BURRIS/WAGNON ARCHITECTS, P.A.

ADDENDUM NO. 2

Re: **Batson Finishes 3rd Floor**
University of Mississippi Medical Center
Jackson, MS
IHL #209-585

BATSON - THIRD FLOOR PLAN - PLUMBING
 SCALE: 1/8" = 1'-0"

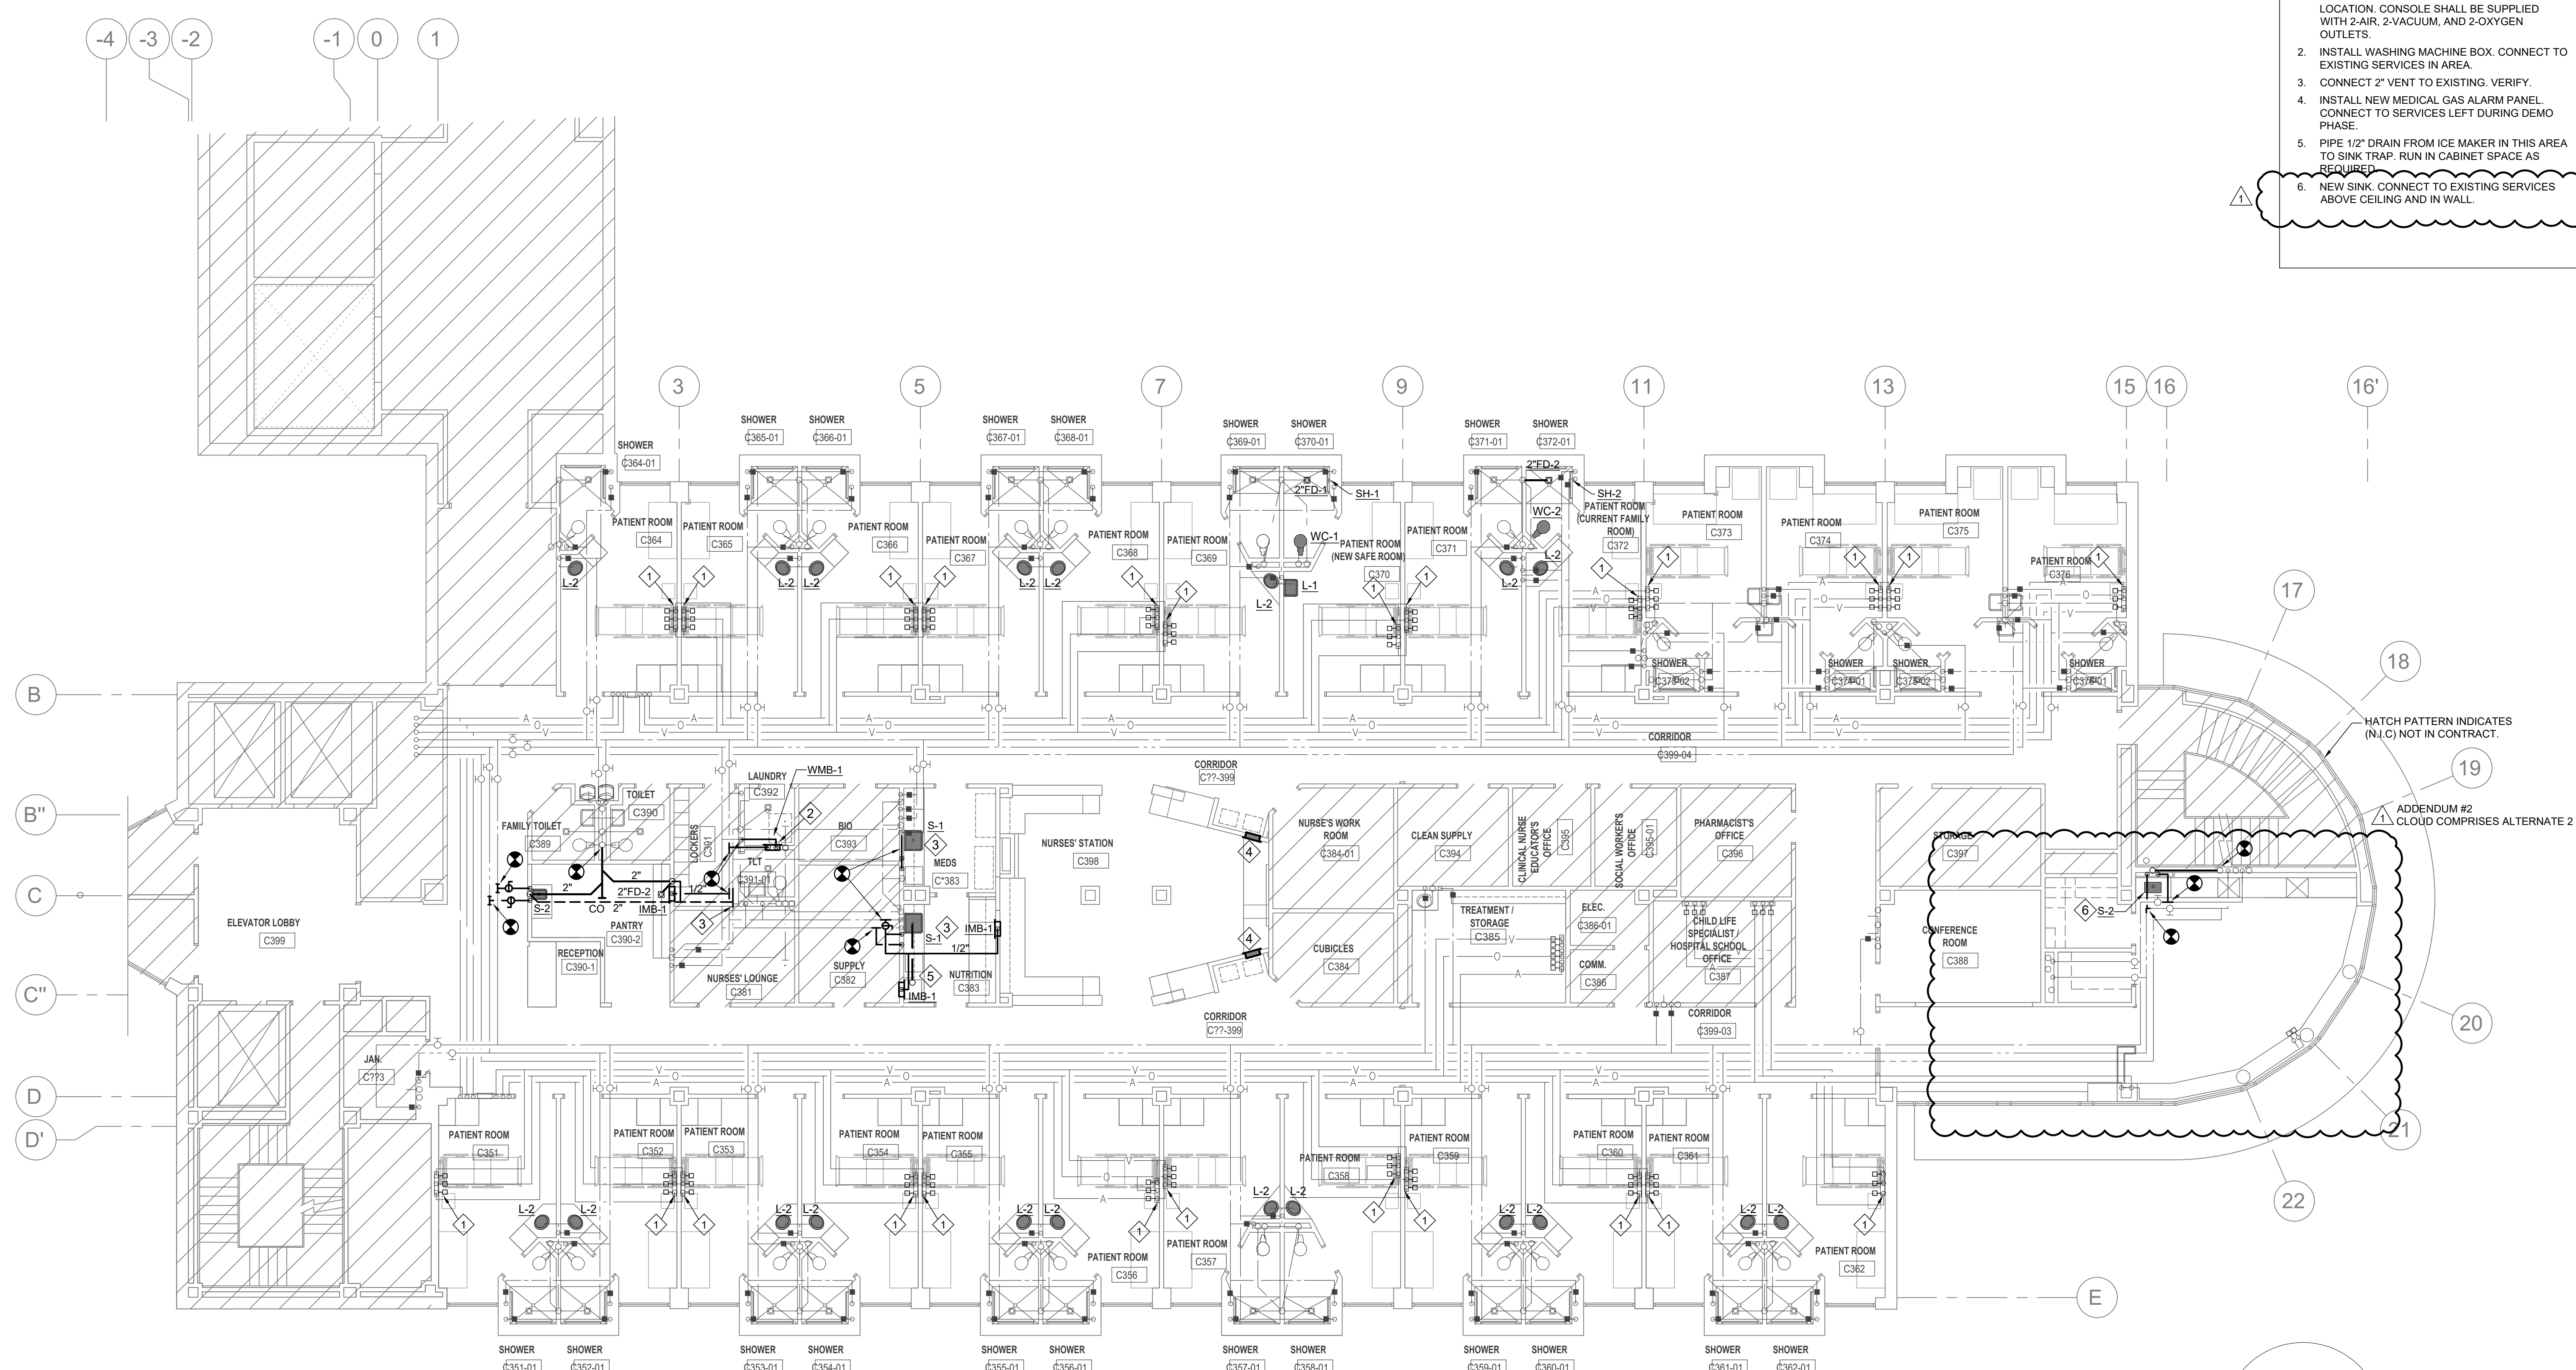
- PLAN NOTES:**
1. CONTRACTOR SHALL MAKE FINAL CONNECT TO ARCHITECT SPECIFIED MEDICAL GAS HEADWALL. CONNECT TO PRE-PIPED MEDICAL GAS HEADWALL APPROXIMATELY THIS LOCATION. CONSOLE SHALL BE SUPPLIED WITH 2-AIR, 2-VACUUM, AND 2-OXYGEN OUTLETS.
 2. INSTALL WASHING MACHINE BOX. CONNECT TO EXISTING SERVICES IN AREA.
 3. CONNECT 2" VENT TO EXISTING. VERIFY.
 4. INSTALL NEW MEDICAL GAS ALARM PANEL. CONNECT TO SERVICES LEFT DURING DEMO PHASE.
 5. PIPE 1/2" DRAIN FROM ICE MAKER IN THIS AREA TO SINK TRAP. RUN IN CABINET SPACE AS REQUIRED.
 6. NEW SINK. CONNECT TO EXISTING SERVICES ABOVE CEILING AND IN WALL.

ADDENDUM #2
CLOUD COMPRISES ALTERNATE 2
